# HAL300 Differential Hall Effect Sensor IC

Edition July 15, 1998  
6251-345-1DS

<b>Subject:</b>	Improvement of SOT-89B Package
<b>Data Sheet Concerned:</b>	HAL 300, 6251-345-1DS, Edition July 15, 1998 HAL 320, 6251-439-1DS, Edition July 15, 1998
<b>Supplement:</b>	No. 1/ 6251-532-1DSS
<b>Edition:</b>	July 4, 2000

**Position of sensitive area**

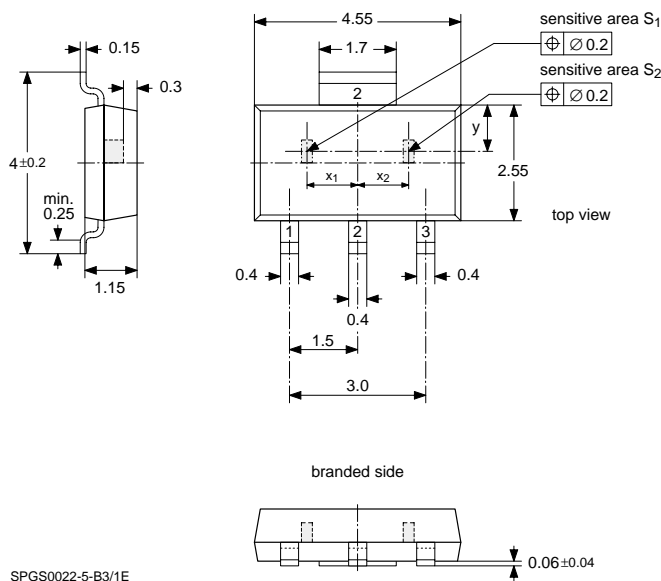
**Changes:**

- position tolerance of the sensitive area reduced
- tolerances of the outline dimensions reduced
- thickness of the leadframe changed to 0.15 mm (old 0.125 mm)
- HAL 300 now available in SOT-89B
- SOT-89A will be discontinued in December 2000

HAL 300	HAL 320
$x_1+x_2$	(2.05±0.001) mm	(2.25±0.001) mm
$x_1= x_2$	1.025 mm nominal	1.125 mm nominal
y	0.95 mm nominal	0.95 mm nominal

**Note:** A mechanical tolerance of ±0.05 mm applies to all dimensions where no tolerance is explicitly given. Position tolerances of the sensitive areas are defined in the package diagram.
